### 3/4.4.6 PRESSURE/TEMPERATURE LIMITS

BRUNSWICK STEAM ELECTRIC PLANT, UNITS 1 AND 2

REQUEST FOR LICENSE AMENDMENT

REMOVAL OF PRESSURE-TEMPERATURE CURVES AND VESSEL SURVEILLANCE

FIGURE 3.4.6.1-1  
PRESSURE-TEMPERATURE LIMITS  
REACTOR VESSEL

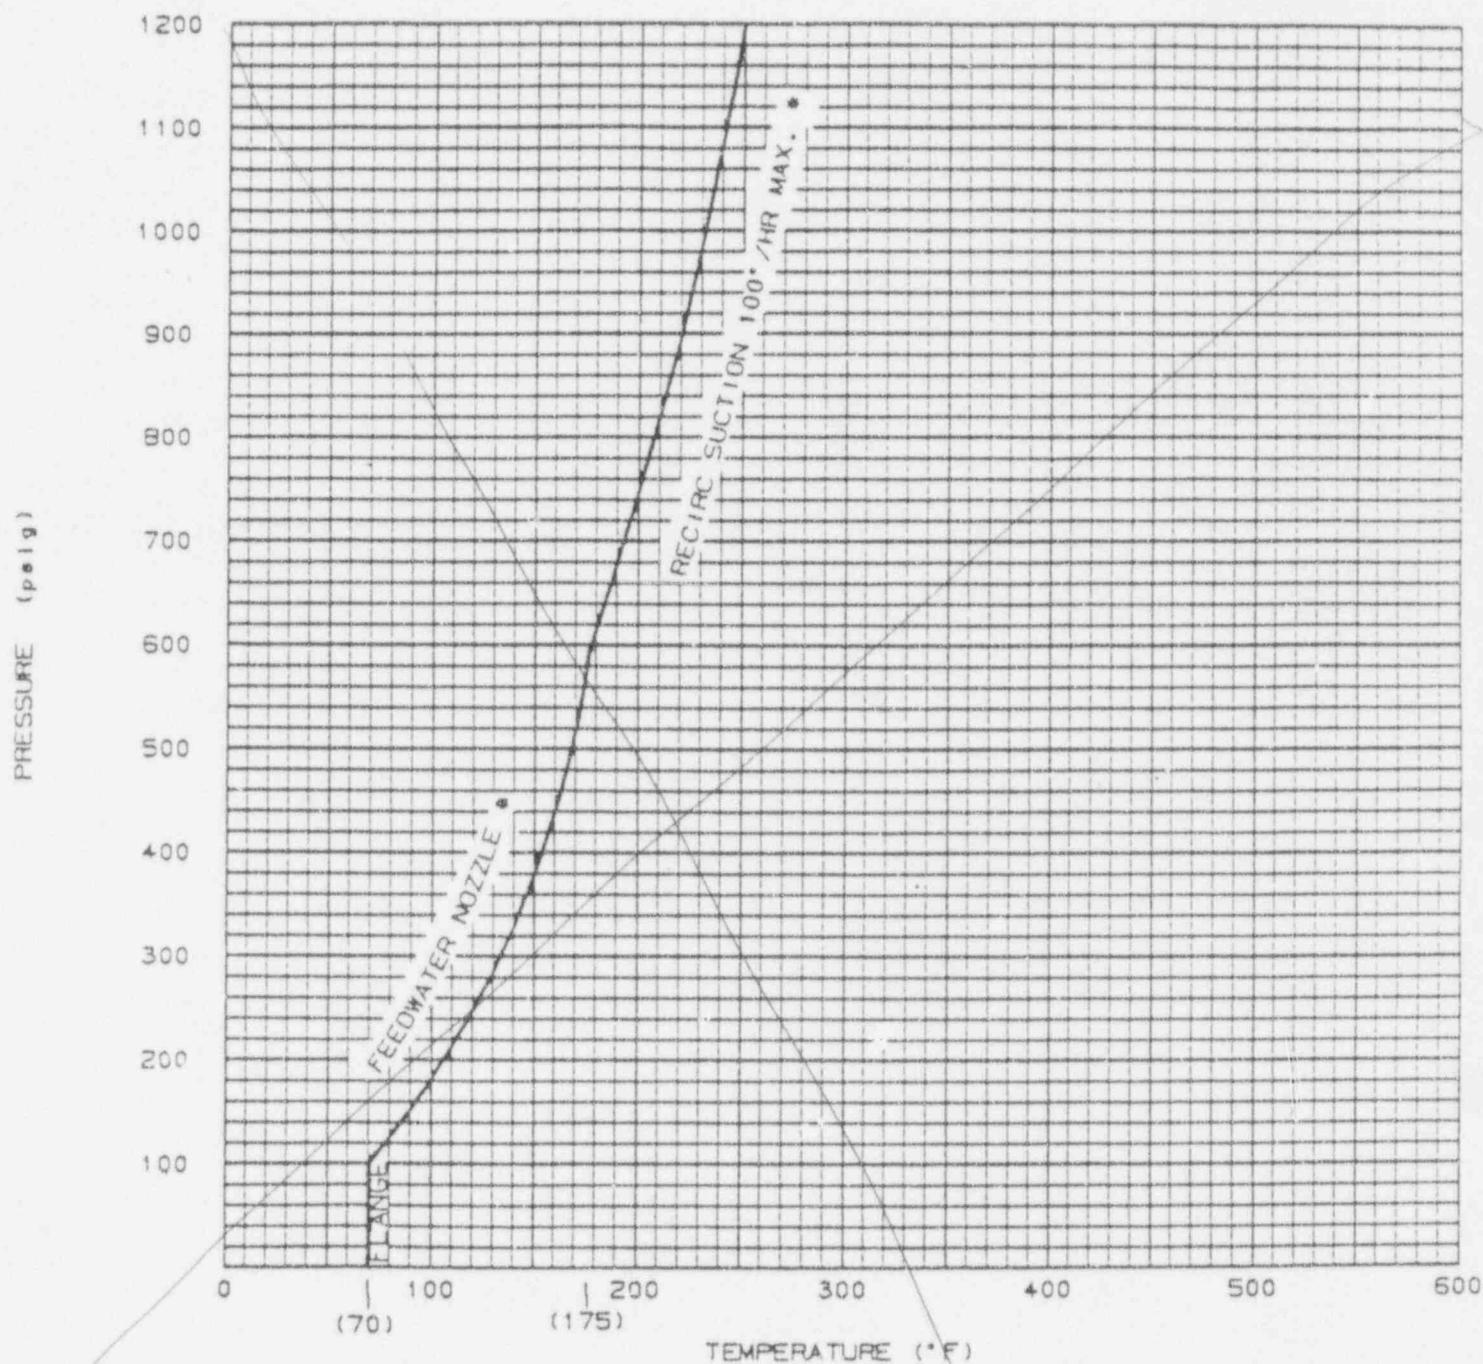
*Delete*

FIGURE 3.4.6.1-2  
PRESSURE-TEMPERATURE LIMITS  
REACTOR VESSEL

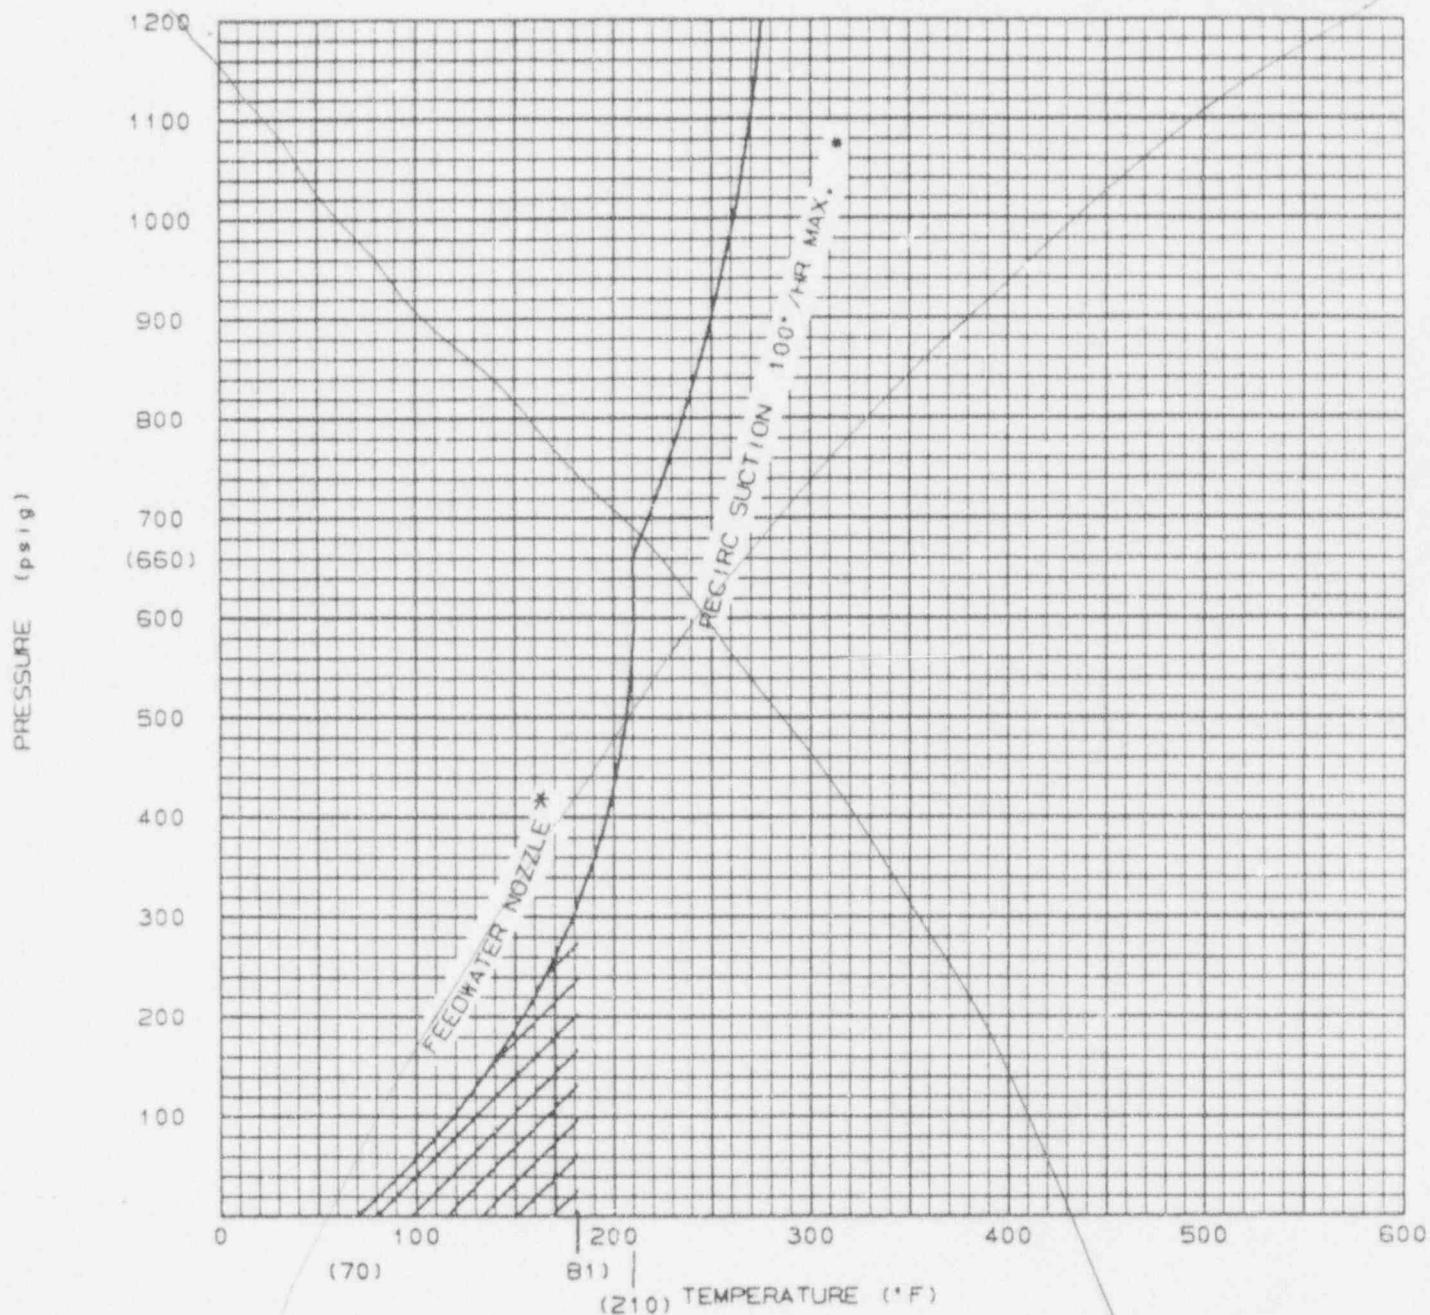
*Delete*

FIGURE 3.4.6.1-3a  
PRESSURE-TEMPERATURE LIMITS  
REACTOR VESSEL

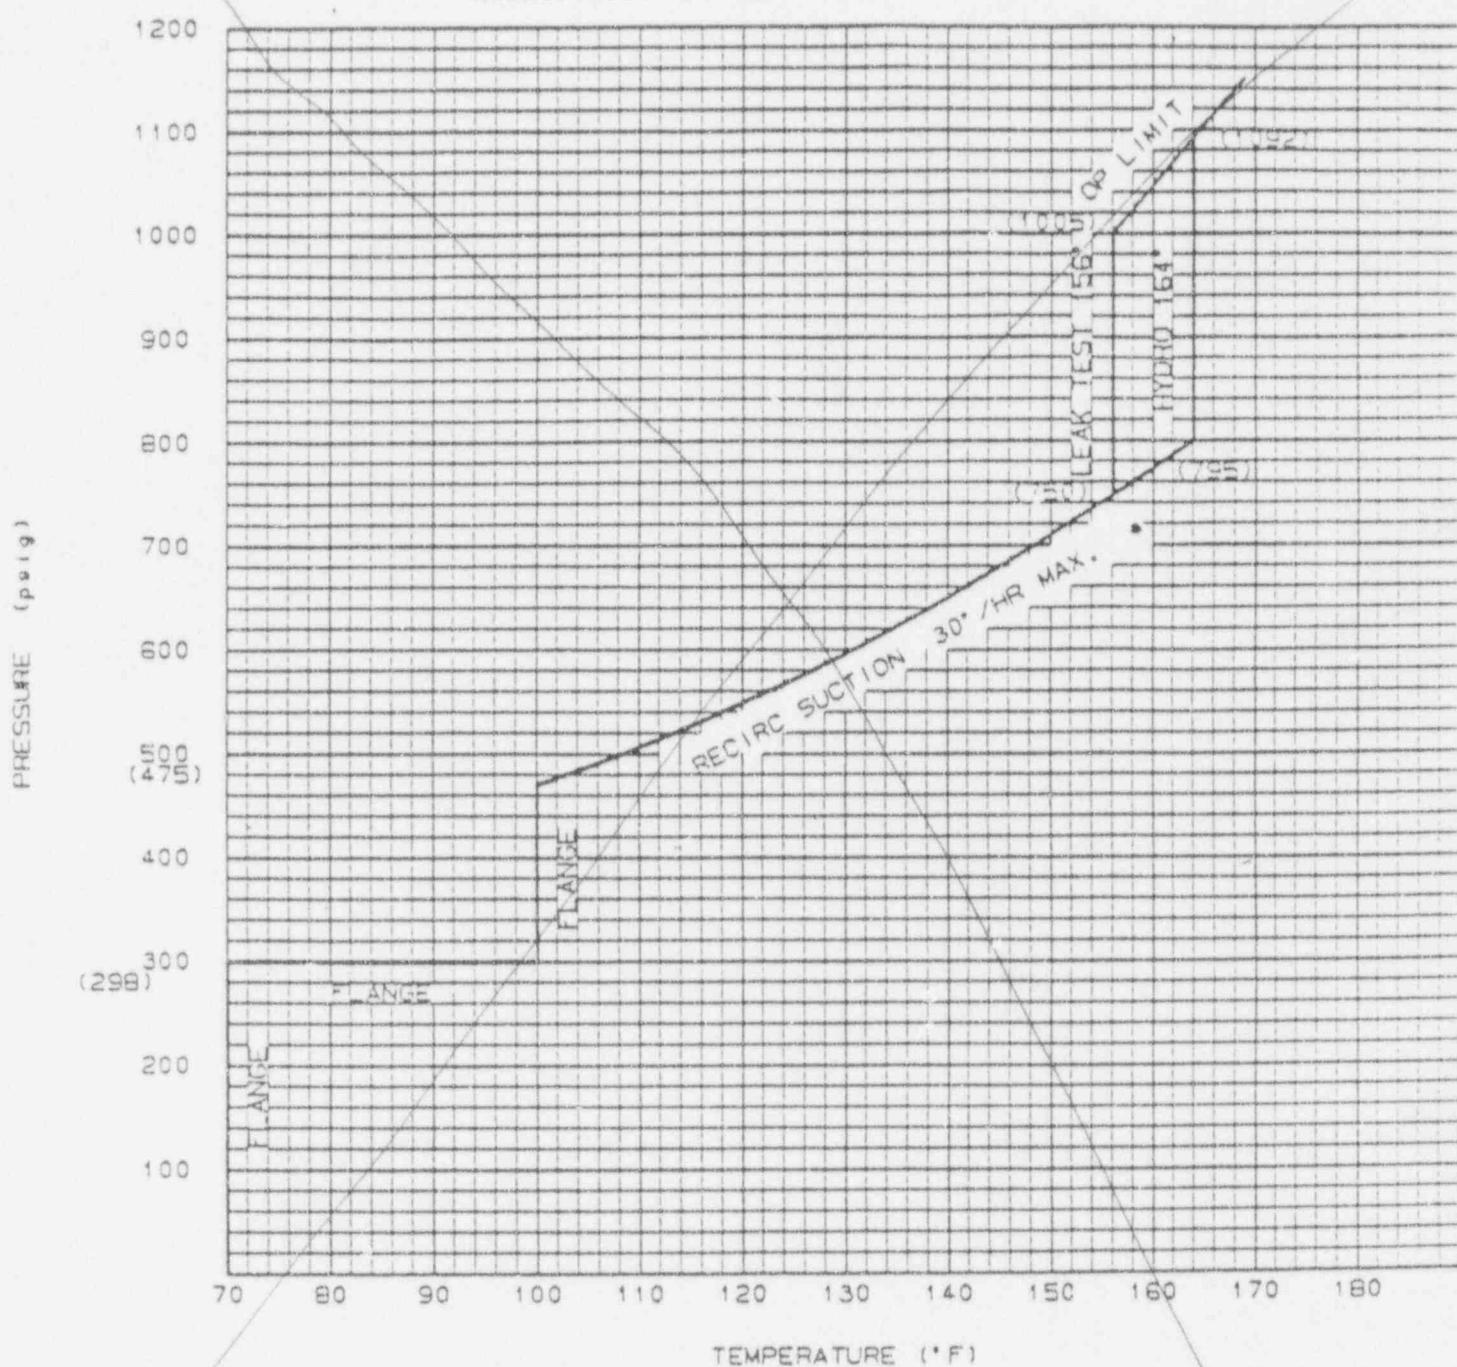
*Delete*

FIGURE 3.4.6.1-3b  
PRESSURE-TEMPERATURE LIMITS  
REACTOR VESSEL

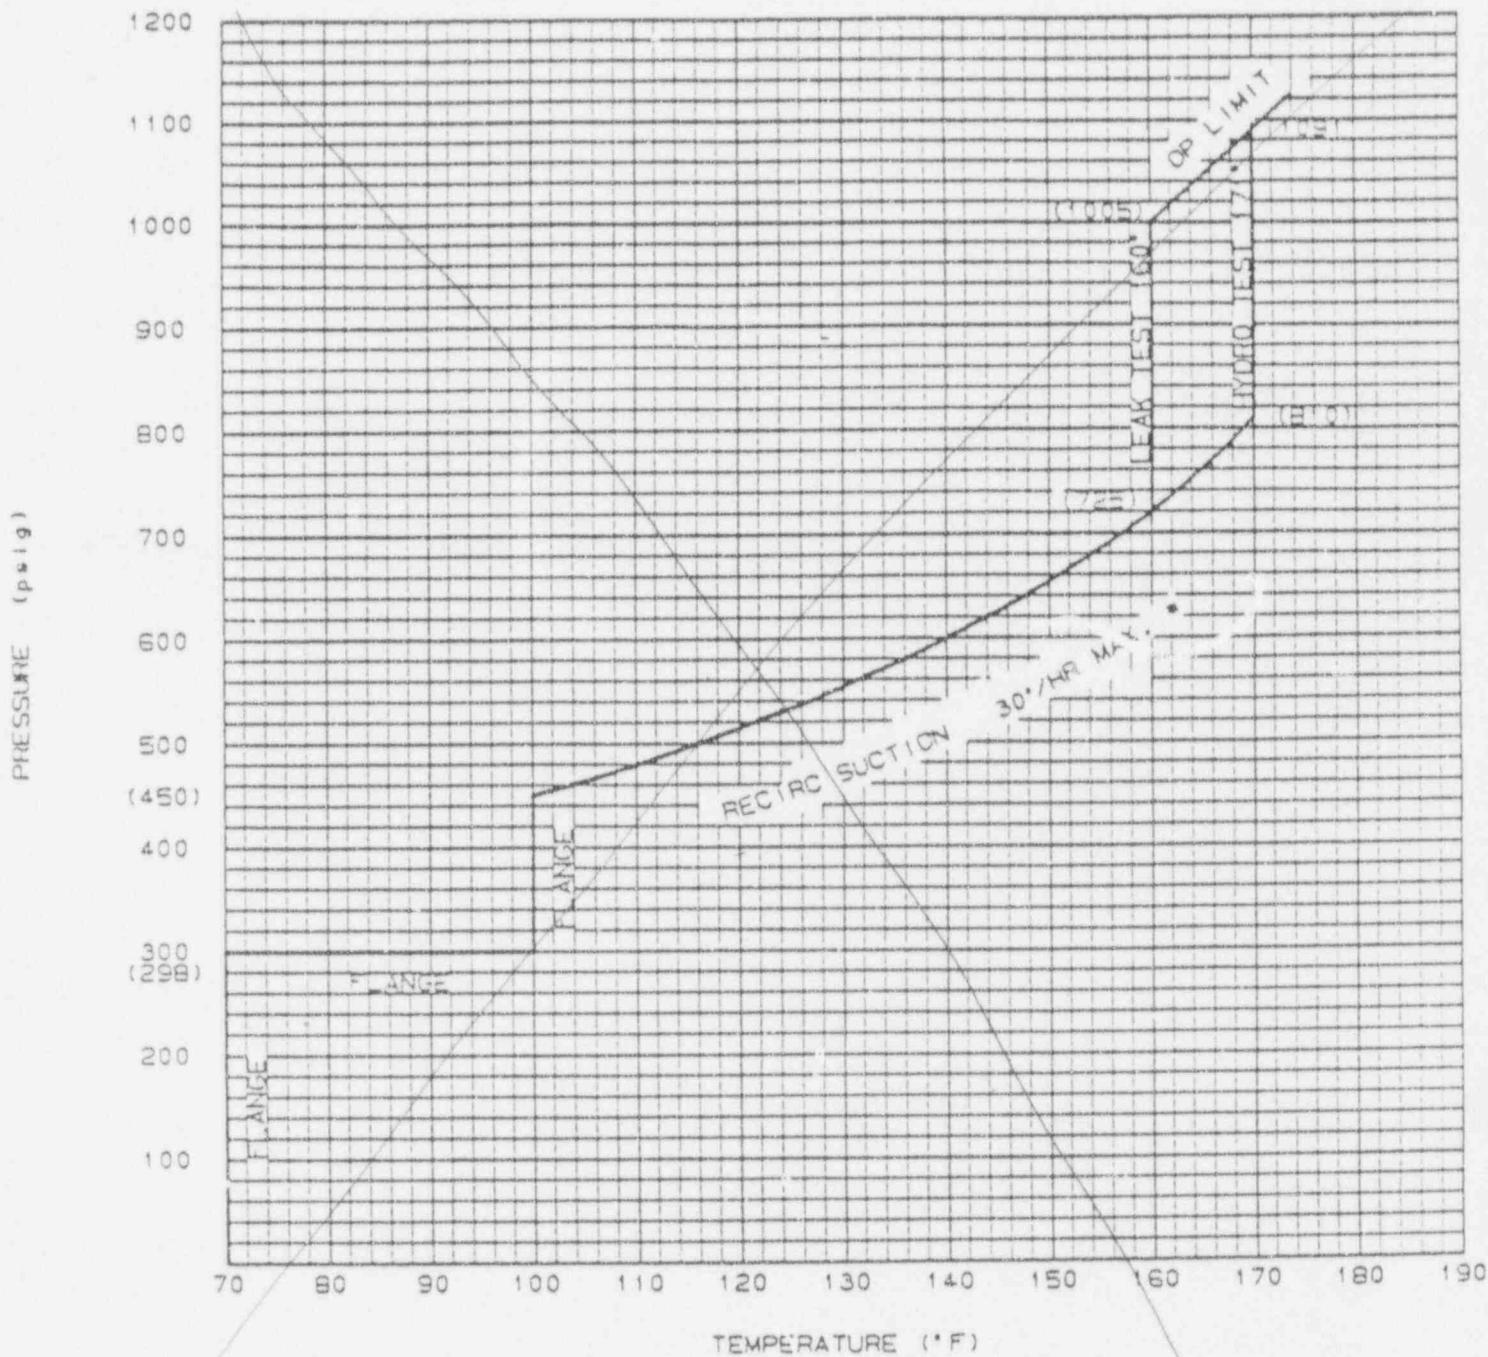
*Delete*

FIGURE 3.4.6.1-3c  
PRESSURE-TEMPERATURE LIMITS  
REACTOR VESSEL

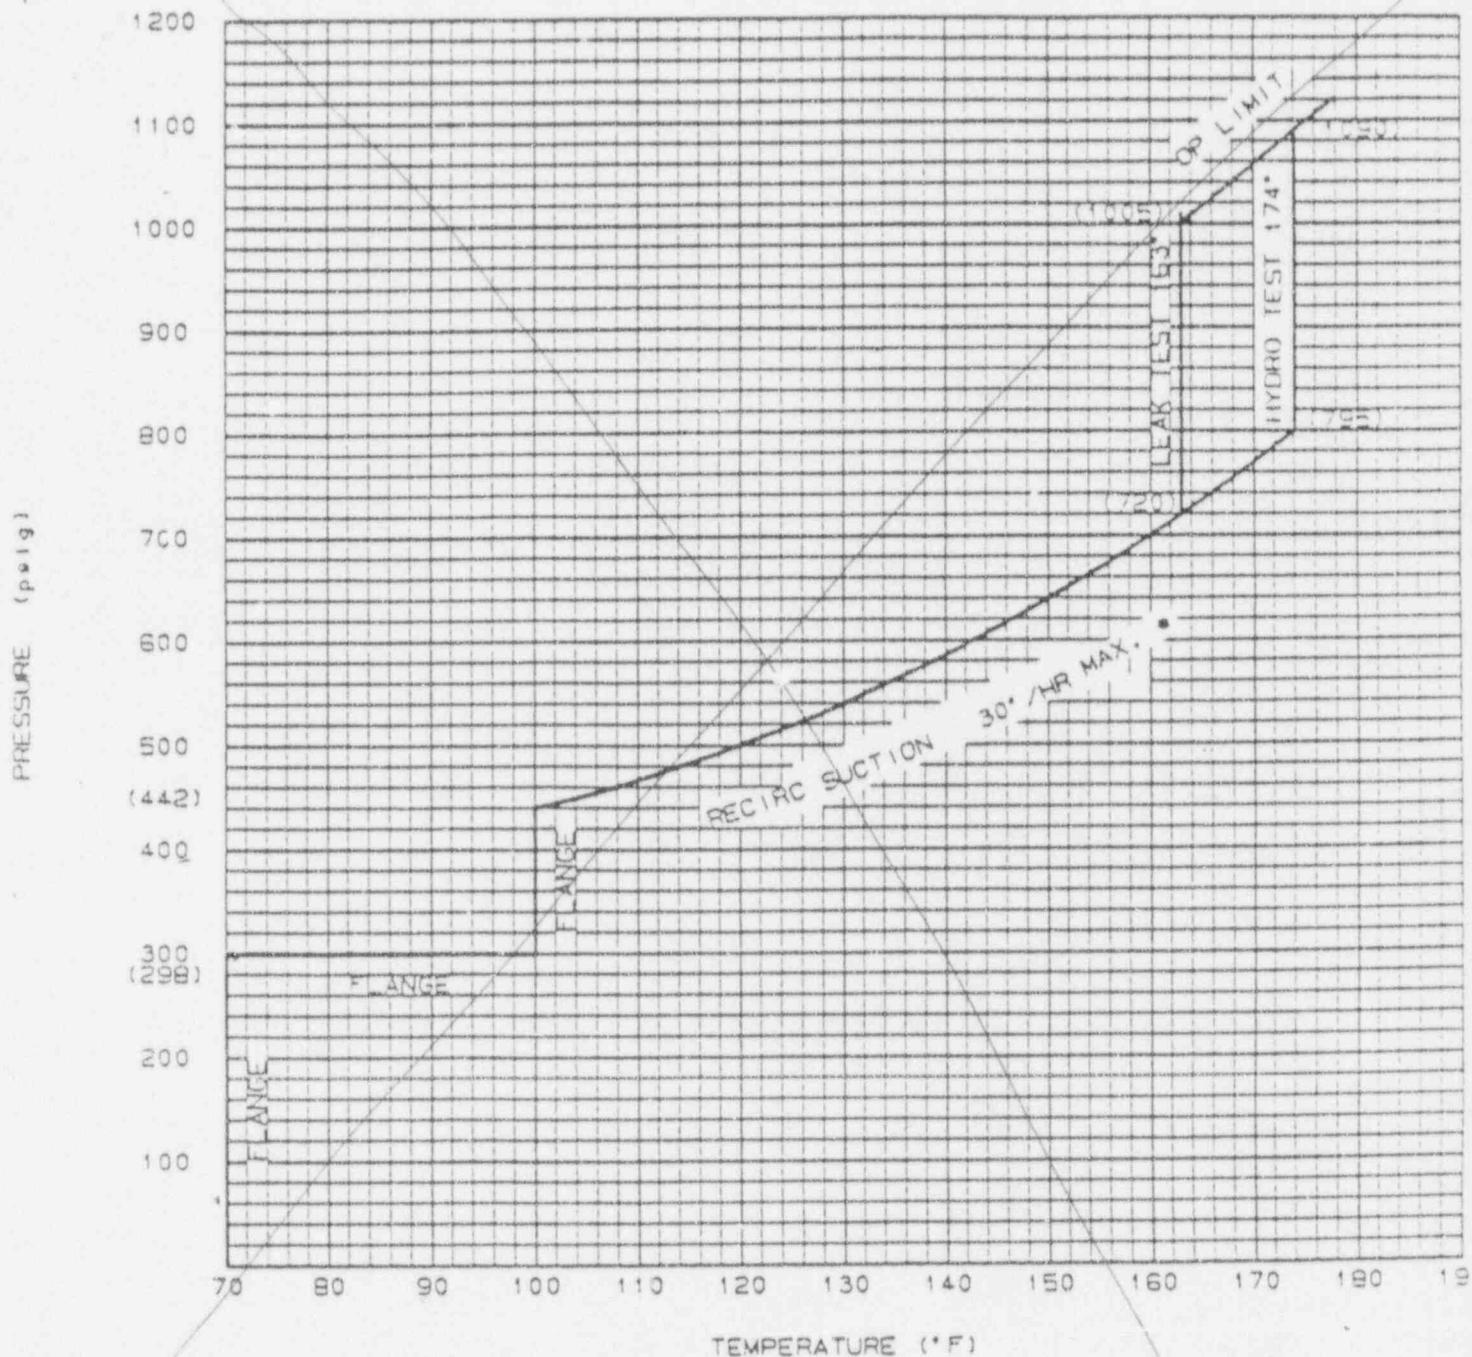
*Delete*
